<b>AMENDMENT OF SOLICITATION/MODIFICATION OF CONTRACT</b>				1. CONTRACT ID CODE	PAGE 1 OF 10 PAGES
2. AMENDMENT/MODIFICATION NO. Amendment No. 0003		3. EFFECTIVE DATE 8/05/11	4. REQUISITION/PURCHASE REQ. NO.	5. PROJECT NO. (If applicable) 100031	
6. ISSUED BY Officer in Charge of Construction MCI-East 1005 MICHAEL ROAD, CAMP LEJEUNE NC 28547-2521		CODE bab	7. ADMINISTERED BY (If other than Item 6) See Item 6		
8. NAME AND ADDRESS OF CONTRACTOR (No., street, county, State and ZIP Code)			(X)	9A. AMENDMENT OF SOLICITATION NO. N40085-10-R-0031	
			X	9B. DATED (SEE ITEM 11) 7/21/11	
				10A. MODIFICATION OF CONTRACT/ORDER NO.	
				10B. DATED (SEE ITEM 11)	
CODE		FACILITY CODE

Project 100031 Repairs to BEQ Building BB260

Amendment 0003

### **SHEET A 402**

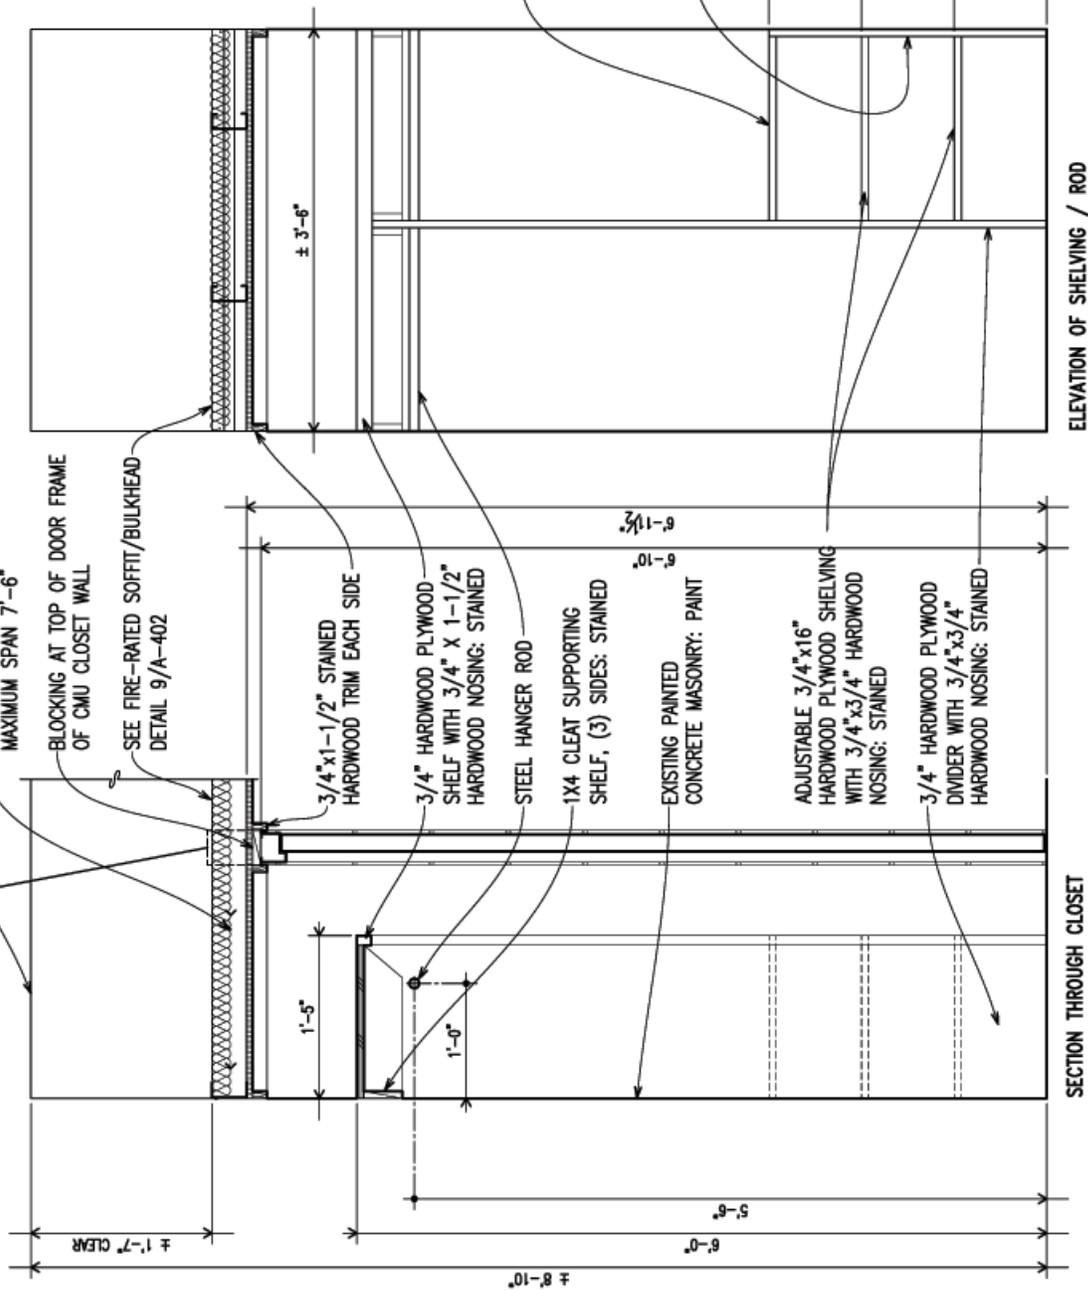
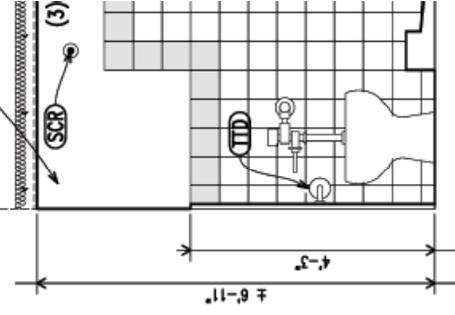
Replace detail 6 with the attached revision.

AT CONTRACTOR'S OPTION: GYPSUM BOARD MAY BE BUTTED TO CMU CLOSET WALL INSTEAD OF PASSING UNINTERRUPTED OVER THE TOP; GYPSUM BOARD MUST HAVE FULL STRUCTURAL SUPPORT AT THAT EDGE AND THE JOINT MUST BE FIRE CAULKED
